RYLANDS BUILDING,
MANCHESTER

COMPARISON PLAN SUB BASEMENT
- NON MATERIAL AMMENDMENT

AL[05]2210

PLANNING DOCUMENT

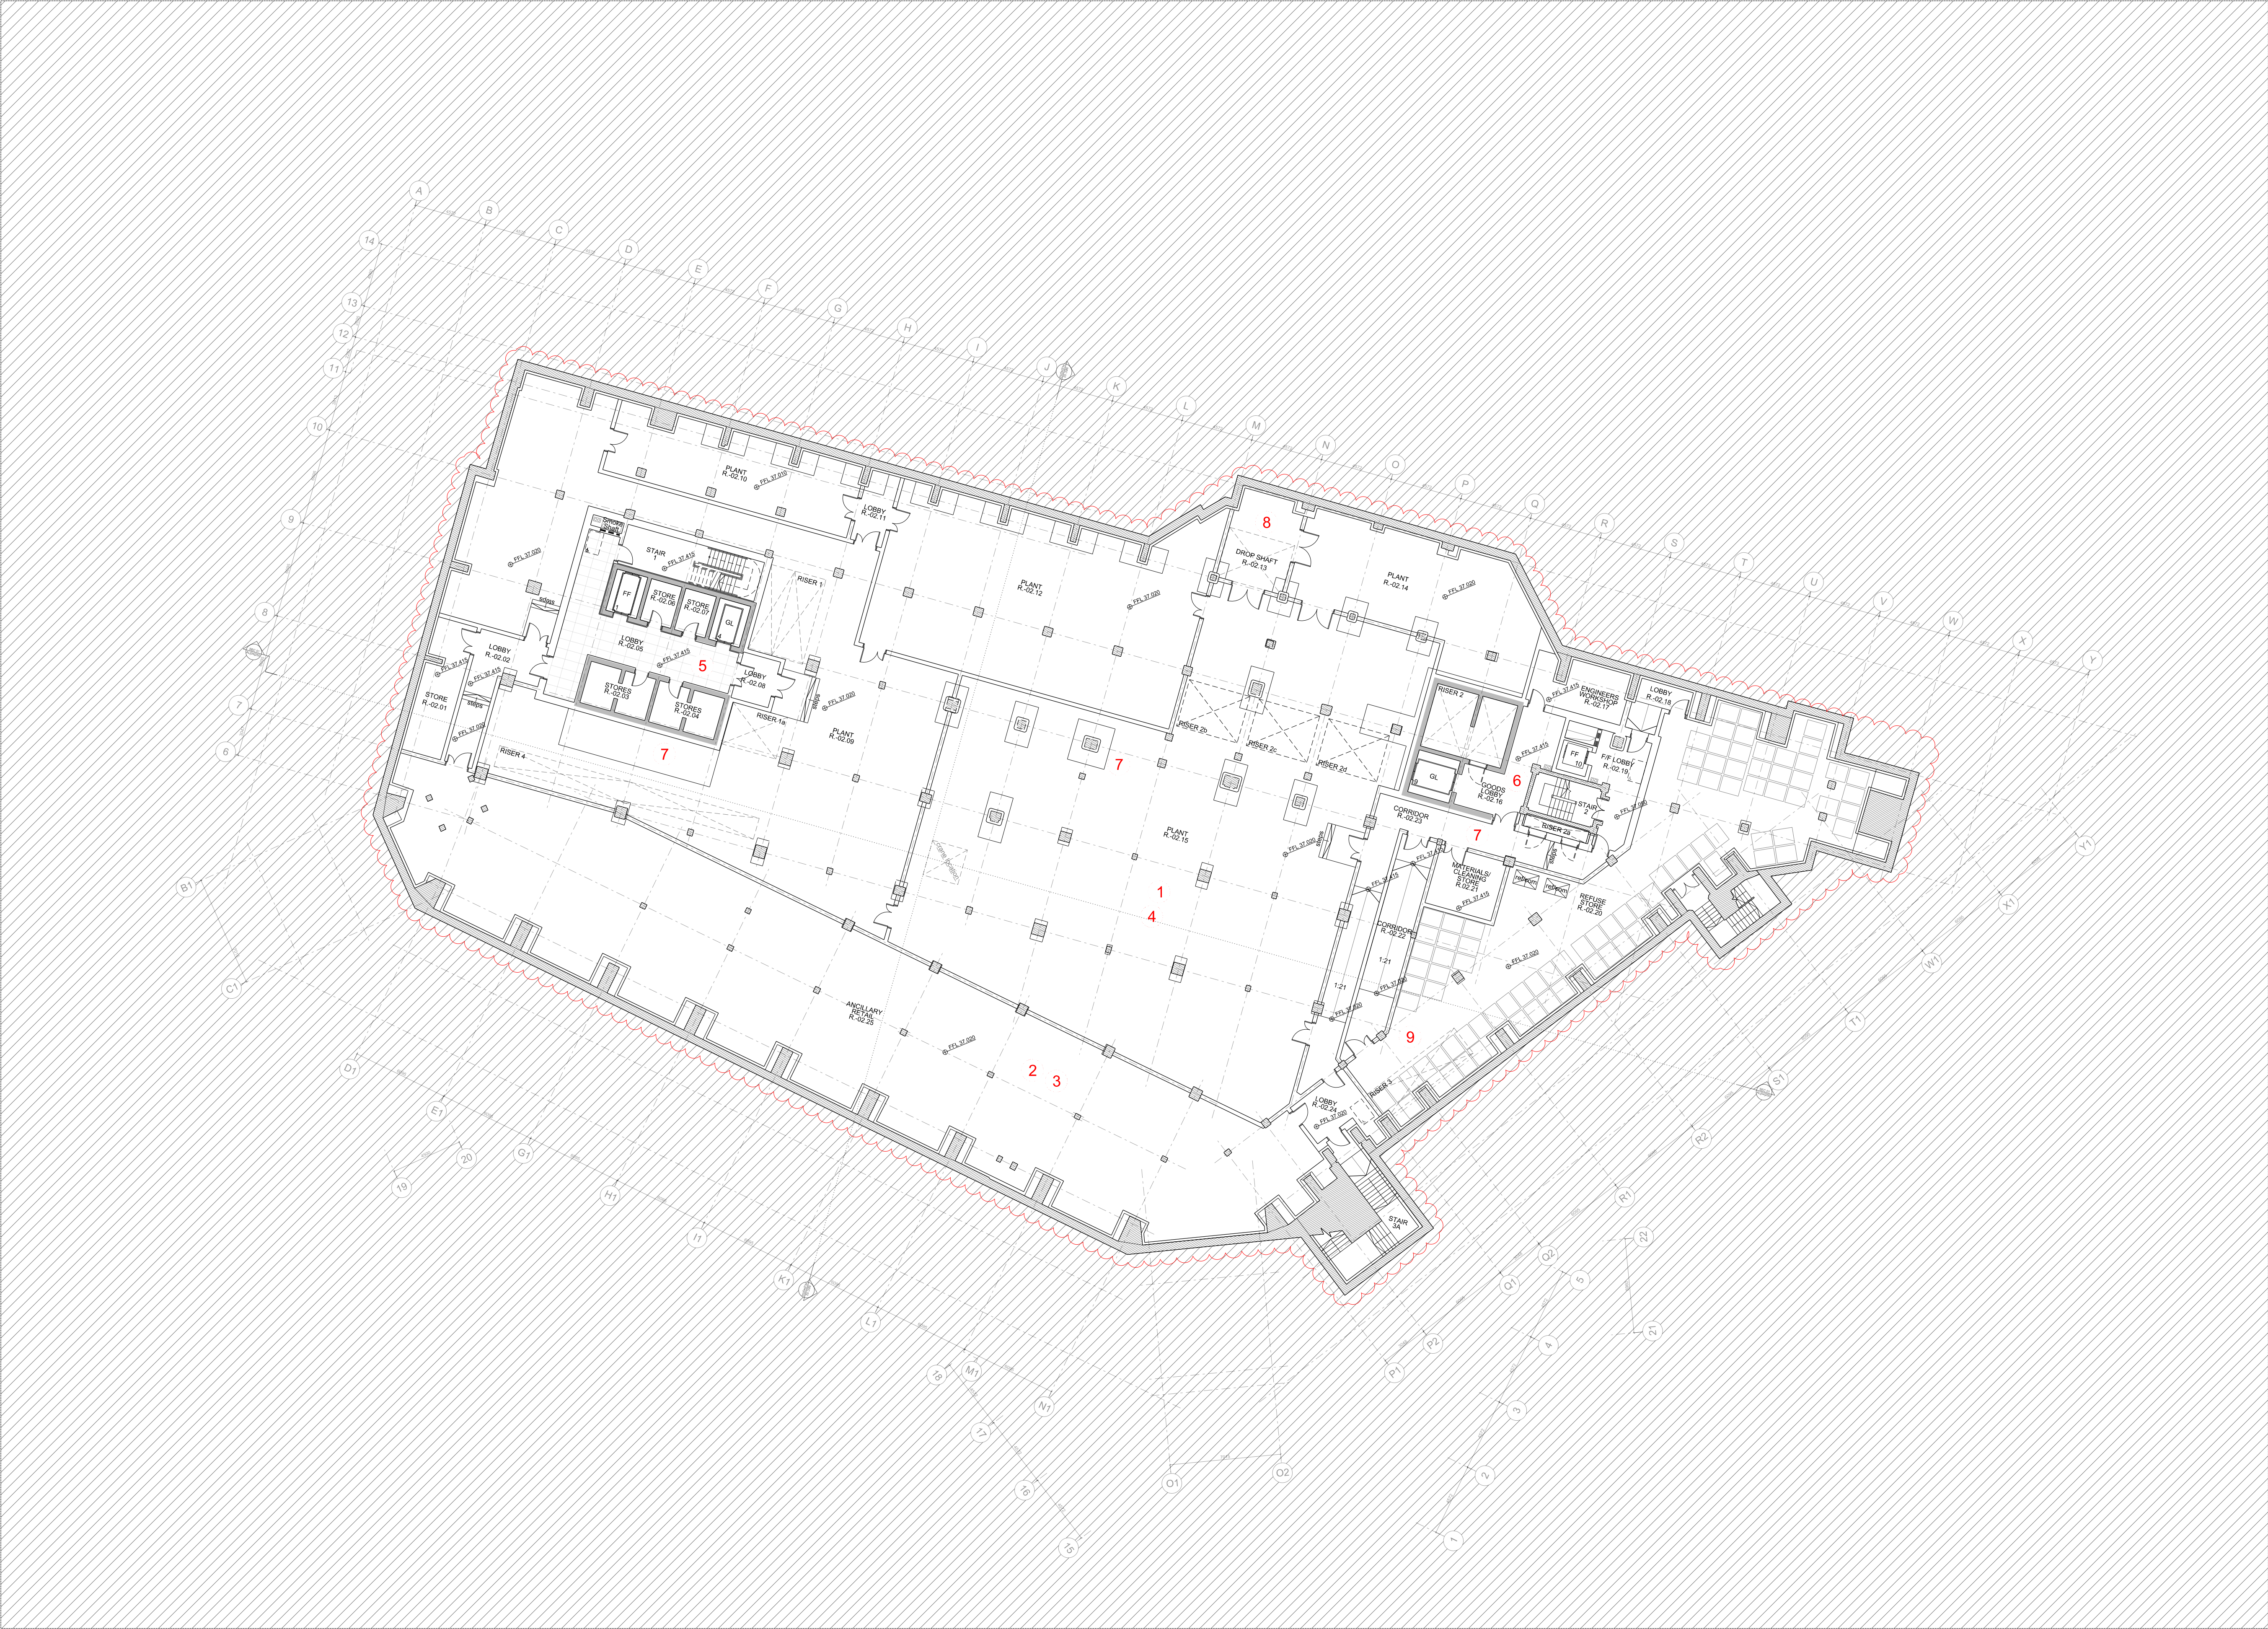
1. Cycle store relocated to basement to reduce structural intervention and simplify building thermal strategy.

2. Wellbeing, showers, and changing relocated to basement to simplify building thermal strategy.

3. Ancillary retail space created.

4. Plant space increased.

5. Stair core 1 arrangement updated to simplify construction.

6. Stair core 2 arrangement updated to reduce works to existing staircase and provide additional goods lift.

7. Foundation levels raised to reduce impact on existing structure.

8. Drop shaft created to facilitate building service strategy.

9. General replan to improve building functionality.
